ROTHER DEVELOPMENT AND SITE ALLOCATIONS LOCAL PLAN

SCHEDULE OF MAIN MODIFICATIONS AND CHANGES TO POLICIES MAPS

July 2019

Modified Detail Map 1 | Figure 7: Strategic Gap at Fairlight [MM7]

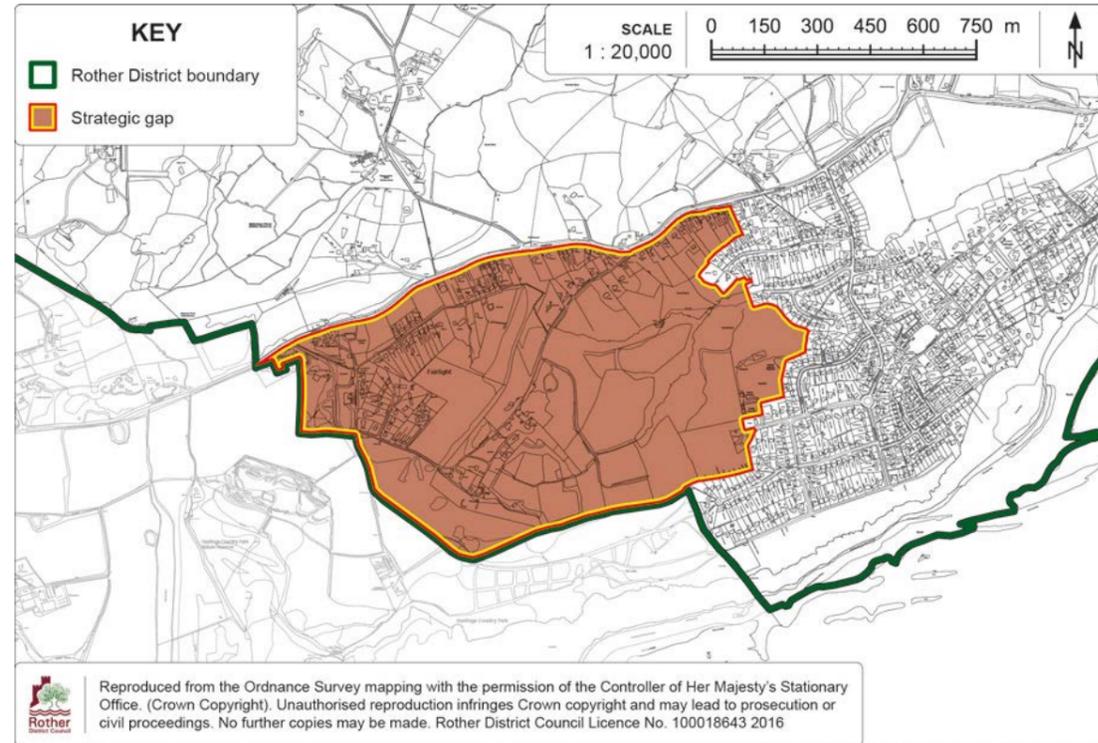
<i>Enhancement of the Gaps through effective landscape management which strengthens and reinforces their significance as protected landscape areas will be supported.</i>	
MM7	Amend the Figure 7 to accord with paragraph 6.21.	Figure 7	Figure 7: Strategic Gap at Fairlight should be amended to include The Close, as described in paragraph 6.21. <u>Please see Appendix 1: Modified Detail Map 1</u> This also applies to Policies Map Inset Map 9: Fairlight Cove, on page 226. <u>Please see Appendix 2: Modified Policies Map 3 for the amended Policy Map Inset Map.</u>	Cartographical error – To make consistent with the supporting text at paragraph 6.21 which refers to The Close being included within the Gap.
MM8	Amendment to paragraph 6.43 to accord more closely with the PPG as to where ecological surveys and reports are required.	6.43	Amend and add to the first sentence of paragraph 6.43 of the supporting text, as follows: <i>Ecological surveys and reports will be required to be submitted with planning applications for major development or where the development impacts on any designated site, Priority Habitat or protected species; proposals which impact on a designated site or Priority Habitat; and proposals where there is a reasonable likelihood of a protected or Priority species being present and affected by the development. Assessments should be proportionate to the nature and scale of development proposed and the likely impact on biodiversity.</i>	To align more closely with the PPG (Paragraph: 016 Reference ID: 8-016-20140612).

Modified Policies Map 1 | Policies Map Inset Map 1b: Bexhill North [MM10] [PMM1] [PMM2]

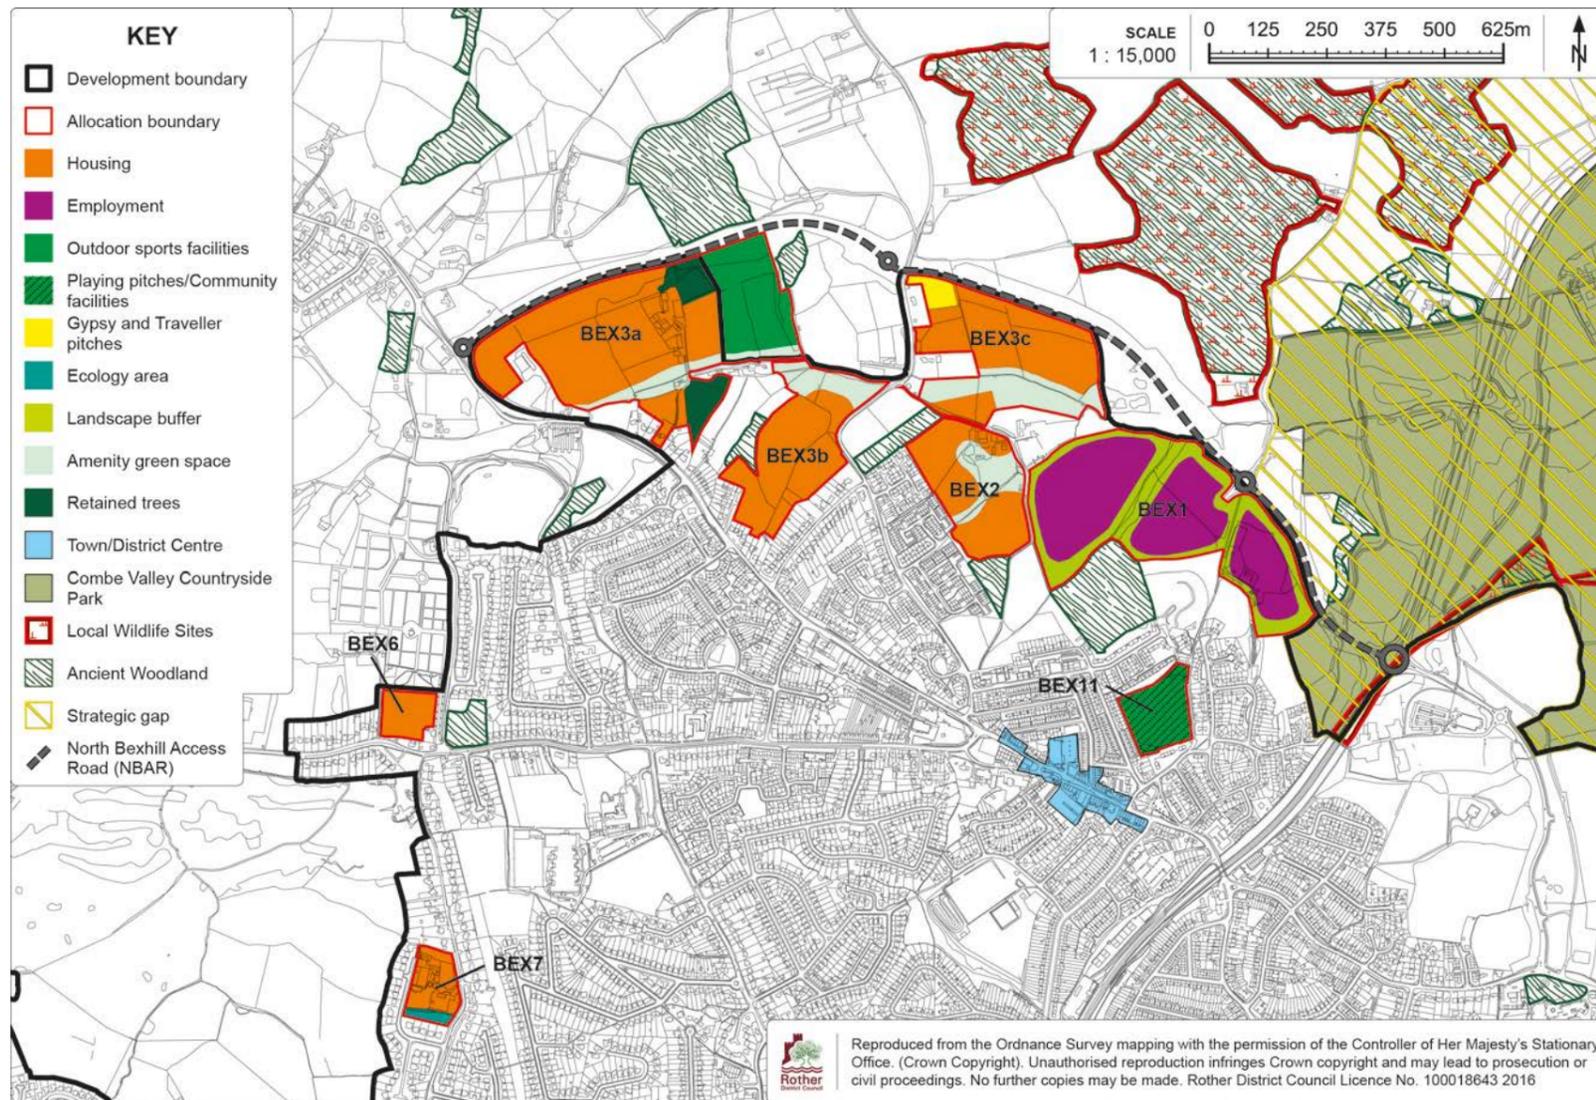
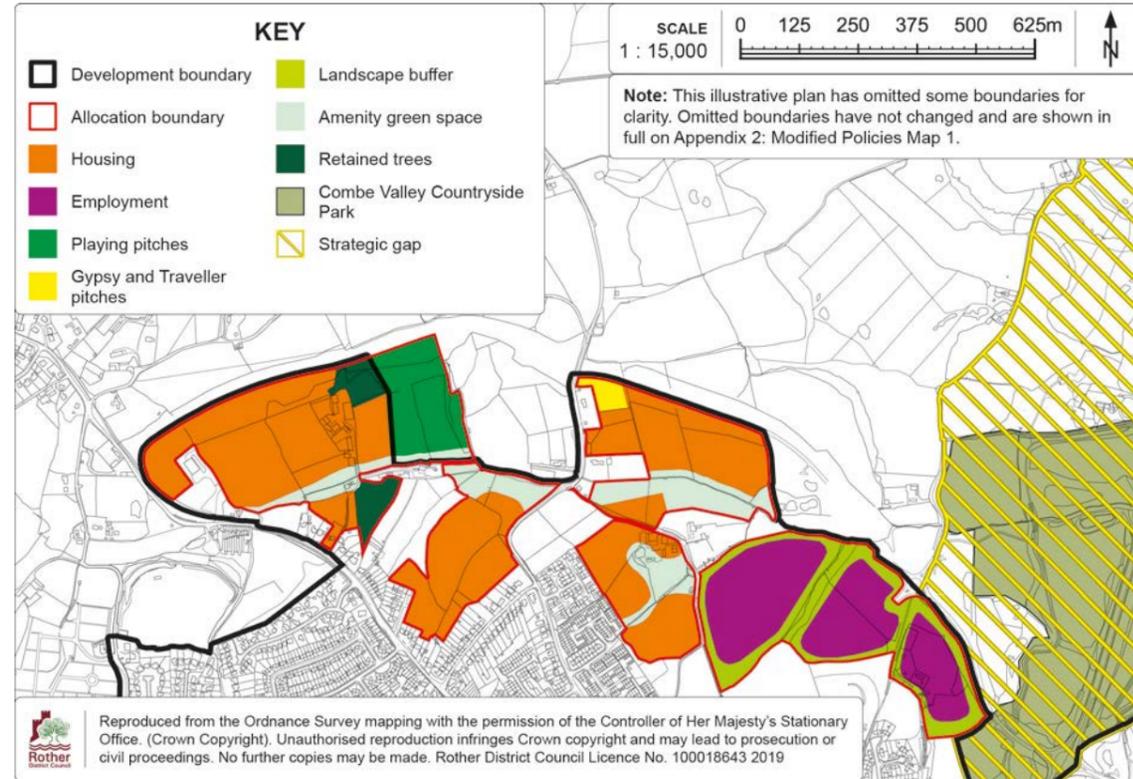
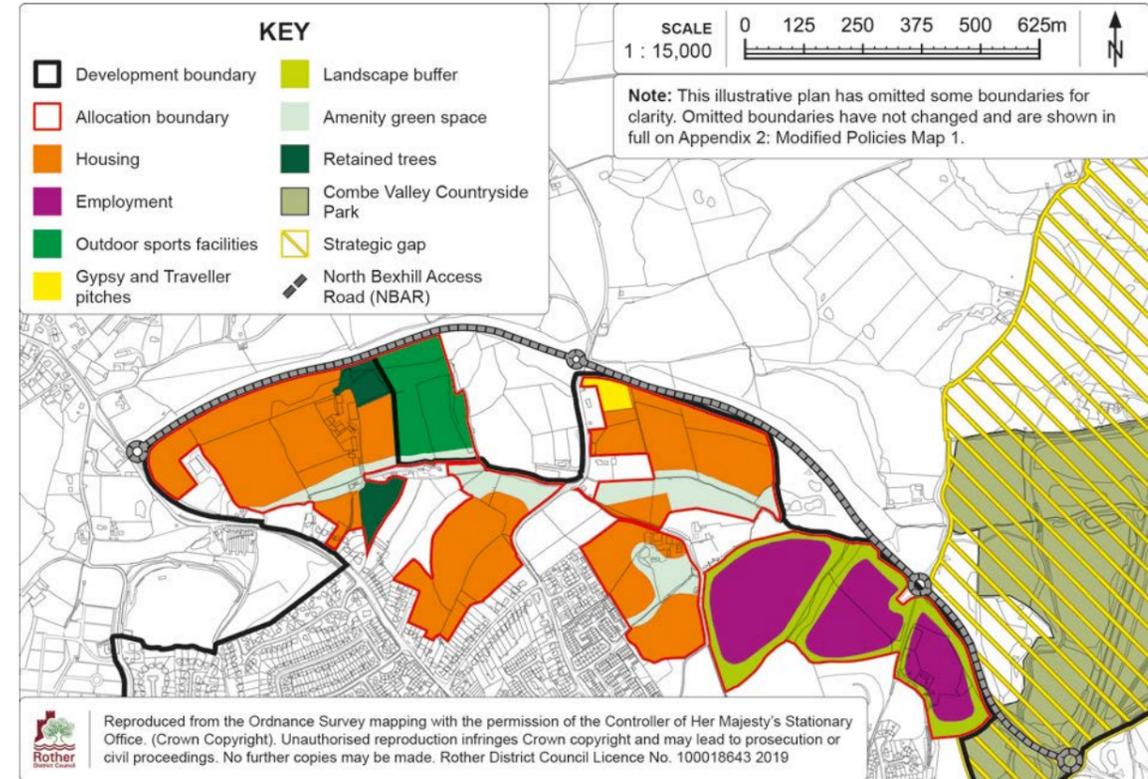
Policies Map Mod #	Page	Policies Map #	Amendment required	Reason
PMM1	172	Policies Map Inset Map 1b: Bexhill North	Amend Policies Map Inset Map 1b: Bexhill North to include NBAR. <u>Please see Appendix 2: Modified Policies Map 1 for the amended Policy Map Inset Map.</u>	Cartographical update: The map should include NBAR for completeness. The new road is complete and has now opened.
PMM2	172	Policies Map Inset Map 1b: Bexhill North	Change 'Playing pitches' to 'outdoor sports facilities' on the Key. <u>Please see Appendix 2: Modified Policies Map 1 for the amended Policy Map Inset Map.</u>	To provide clarity on the intended use of the land for 'outdoor sports facilities' in line with the Open Space, Sport and Recreation Study which supports Policy CO3 of the Rother Local Plan Core Strategy, rather than using the terms 'playing pitches' specifically.
PMM3	203	Policies Map Inset Map 6: Broad Oak	Amend Policies Map Inset Map 6: Broad Oak to reflect the amendments made to Figure 45 (Policy BRO2 Detail Map) which moves the western boundary of the northern section of the housing area (shown in orange) on Figure 45 by a marginal amount to accord with drawing no. 1802-P-204_B, submitted pursuant to planning application RR/2018/1813/P. <u>Please see Appendix 2: Modified Policies Map 2 for the amended Policy Map Inset Map.</u>	To accord with the additional wording required to Policy BRO2 in light of the revised capacity assessment undertaken by Southern Water, and to accord with drawing no. 1802-P-204_B, submitted pursuant to planning application RR/2018/1813/P which was approved on 12 February 2019.

Policy BEX3a (ii)	Delete the wording "playing fields" from the first line and replace with "outdoor sports facilities", i.e.: <i>an open space to include provision for playing fields outdoor sports facilities of at least 2.64 hectares is set aside and laid out in the area indicated on the Detail Map;</i>	
		Policy BEX3a (viii)	Delete the wording "playing fields are" from the first line and replace with "outdoor sports facilities shall be", i.e.: <i>the playing fields are outdoor sports facilities shall be laid out at the same time as housing development, in accordance with a phasing plan to be agreed with the local planning authority;</i>	
		Figure 21	Change 'outdoor sports provision' to 'outdoor sports facilities' on the Key. <u>Please see Appendix 1: Modified Detail Map 2</u>	
		Policies Map Inset Map 1b: Bexhill North	Change 'Playing pitches' to 'outdoor sports facilities' on the Key. <u>Please see Appendix 2: Modified Policies Map 1 for the amended Policy Map Inset Map.</u>
